THE CHURCH OF JESUS CHRIST OF LATTER-DAY SAINTS

CONDITIONAL USE PERMIT

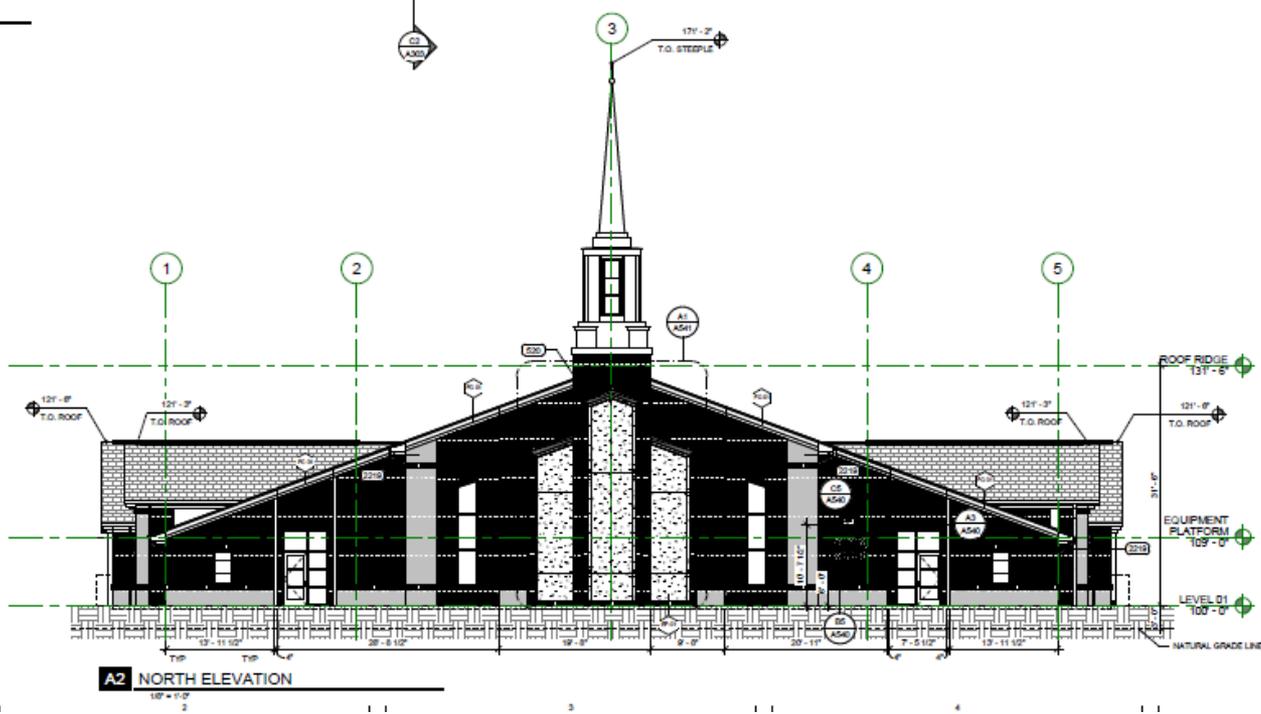
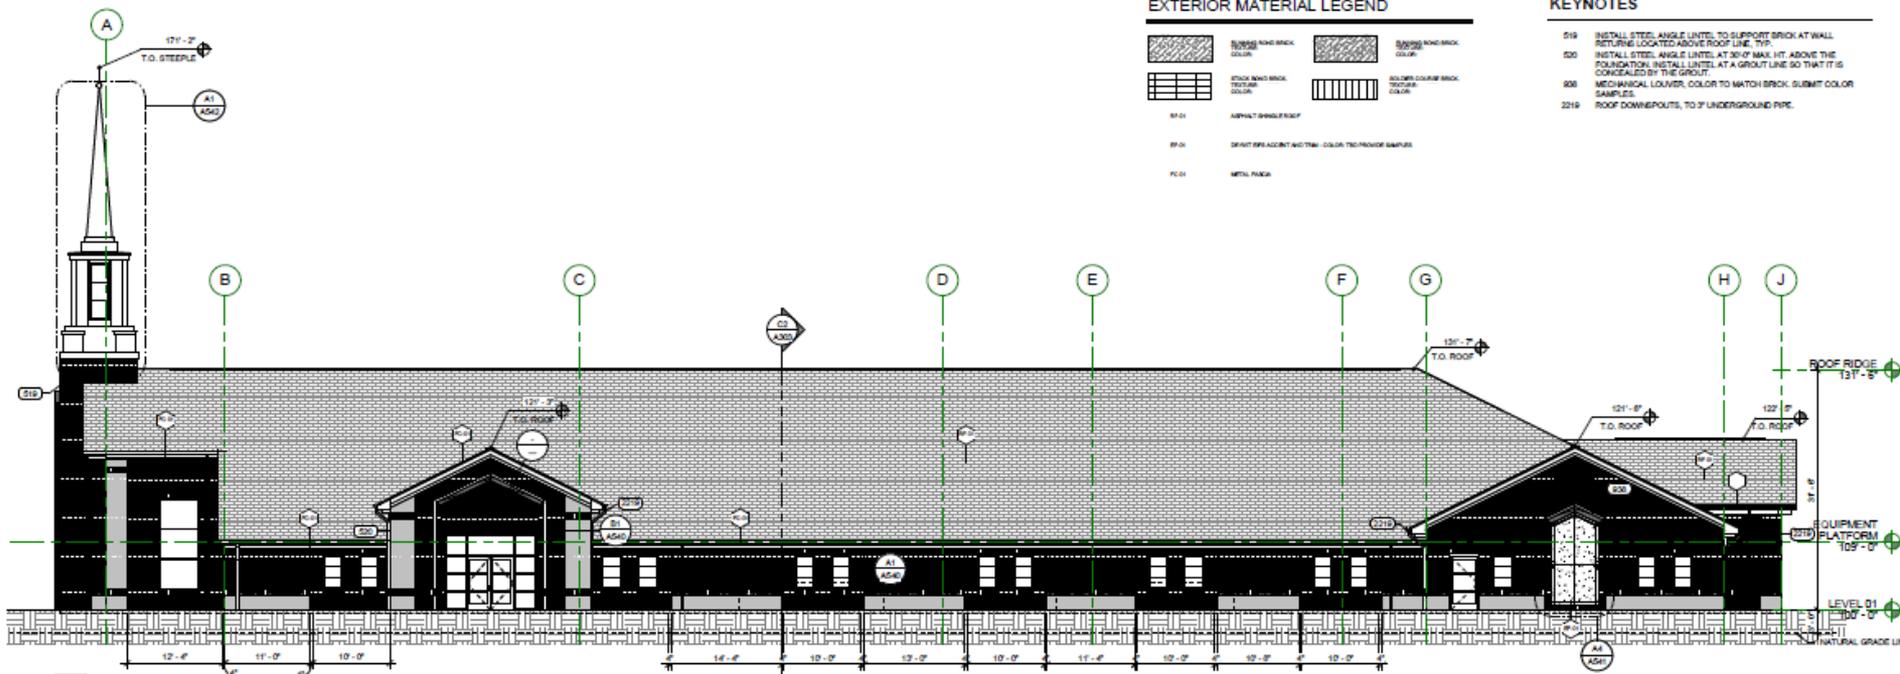
1. The proposed steeple has a height of 71' 2" and does not comply with the height limit of 70', based on a setback 50' from the front property line. Construction drawings must have the steeple height reduced to 70' to comply with code.
2. Lighting shall comply with the City's current lighting ordinance.
